## REFUELING OPERATIONS

### SPENT FUEL CASK HANDLING CRANE

3.9.13 Crane travel of the spent fuel shipping cask crane shall be restricted to prohibit a spent fuel shipping cask from travel over any area within one shipping cask length of any fuel assembly.\*

FIGURE 1  
 AREA OF SPENT FUEL <sup>POOL</sup> IMPACTED BY CASK

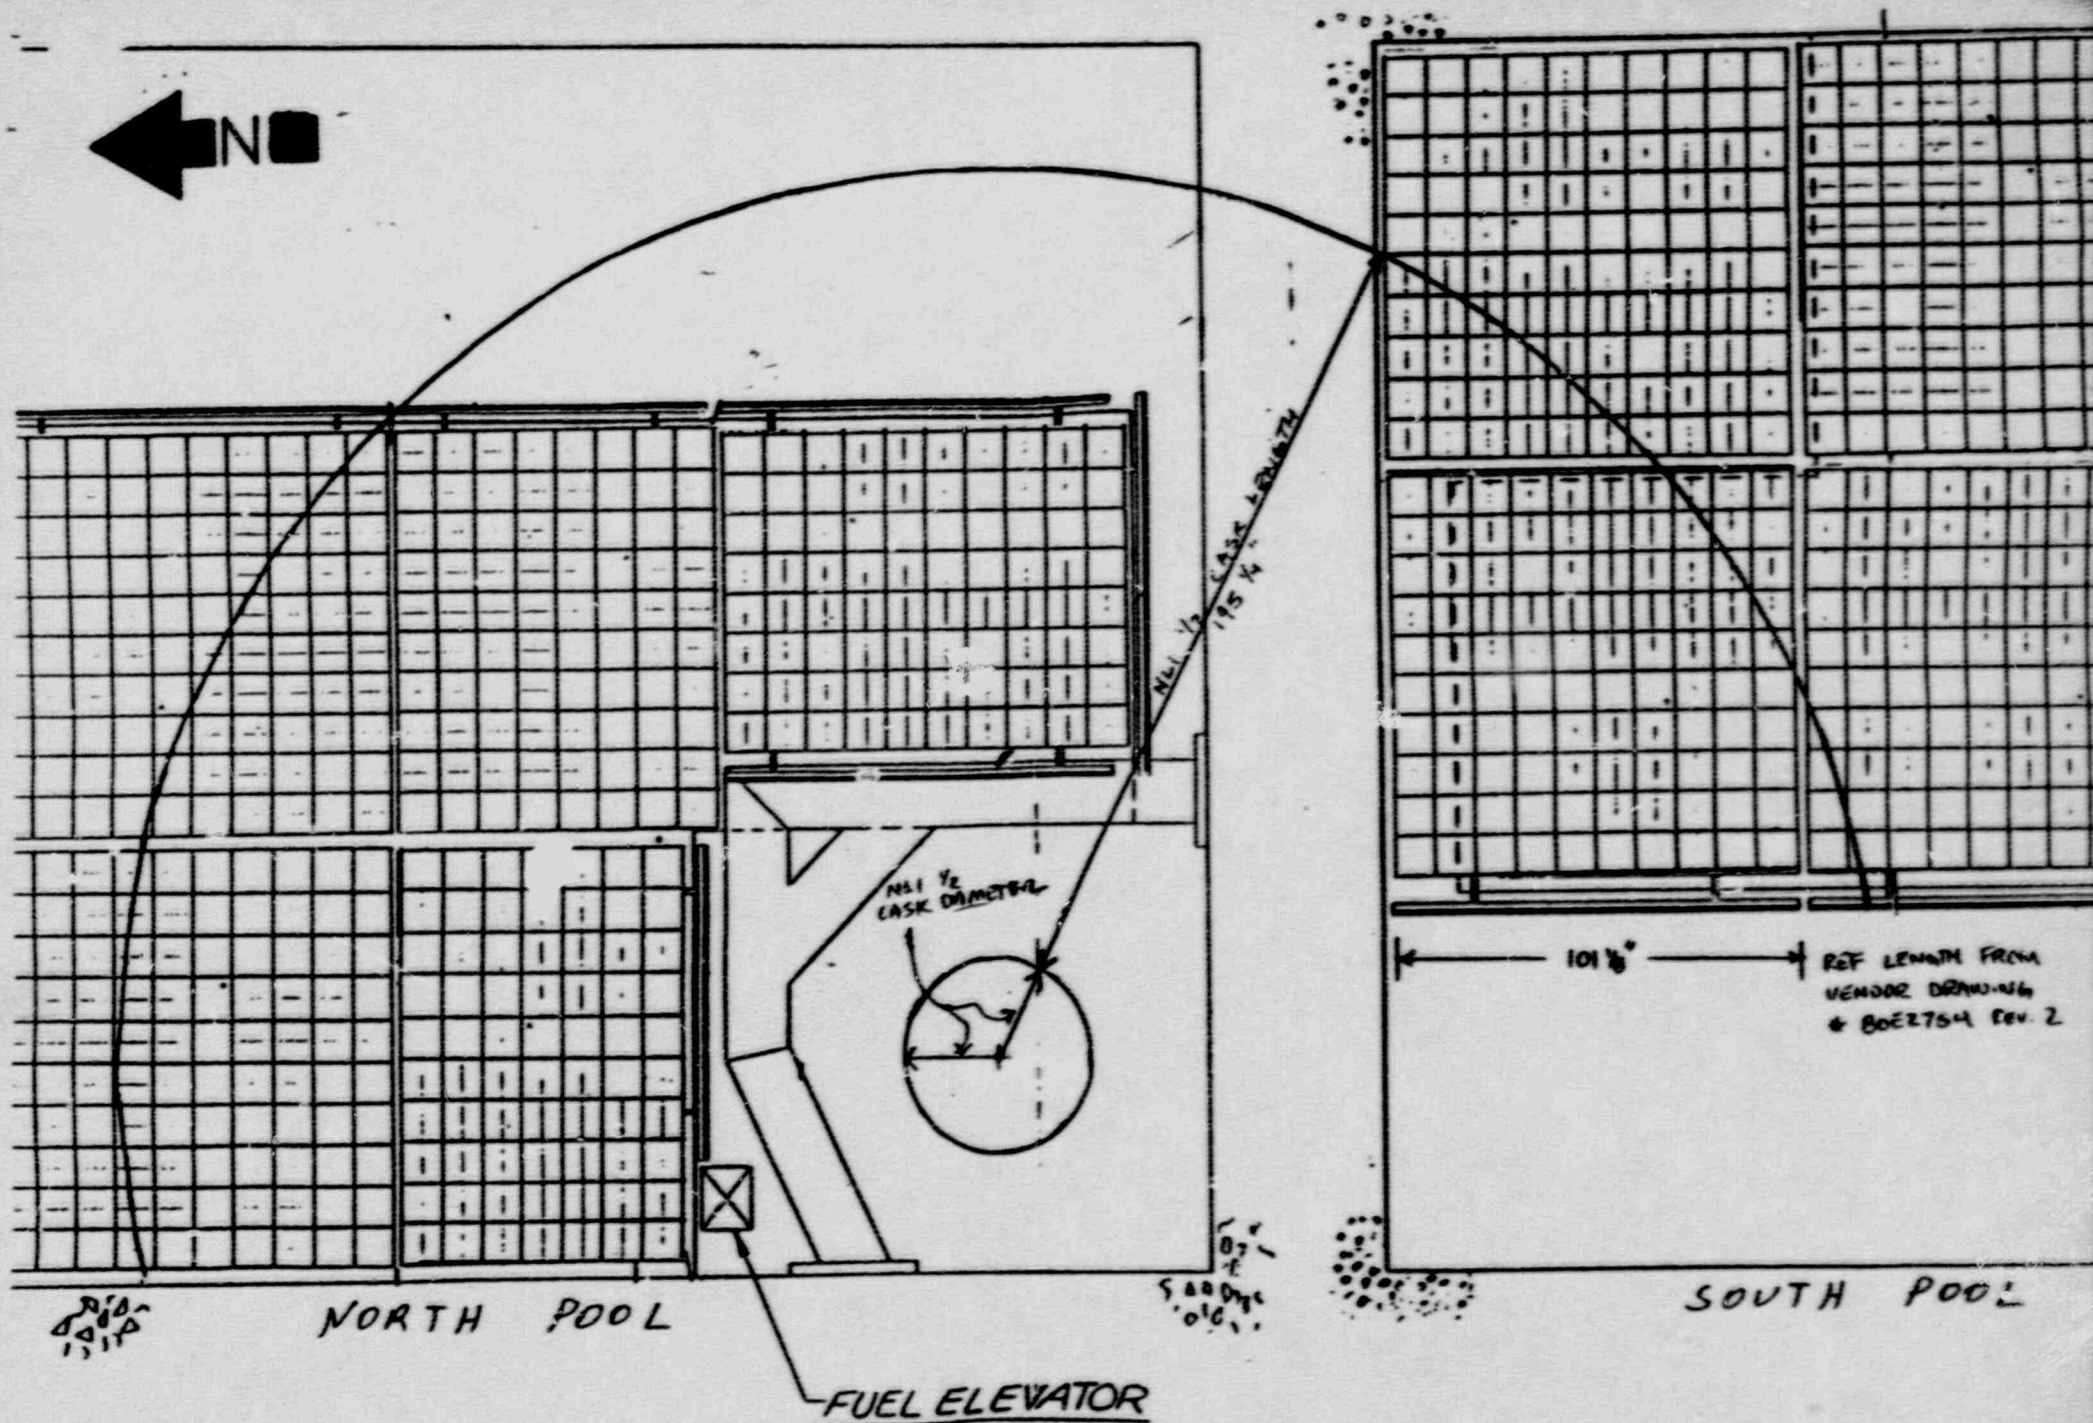
These conditions are modified to permit shipping cask travel to and from the cask pit in the presence of fuel within one cask length radius of the pathway provided the boric acid concentration in the spent fuel pool is greater than or equal to 1000 ppm AND the following criteria are met by all assemblies within one cask length radius of the pathway: 1) initial enrichment less than or equal to 4.1 w/o U-235, 2) Burnup greater than or equal to 28,000 MWD/MTU, and 3) greater than 440 days elapsed from the shutdown of the last operating cycle in which the assembly was present in the core. Crane interlocks and physical stops which restrict a spent fuel shipping cask from passing over any area within one shipping cask length of any fuel assembly not satisfying the above criteria shall be demonstrated OPERABLE within 24 hours prior to using the crane for moving a cask within one length of fuel assemblies meeting the above criteria. These modifications are applicable only to the shipment of fuel rods supporting the EPRI sponsored hot-cell work and for the shipment of a reactor vessel weld material surveillance capsule.
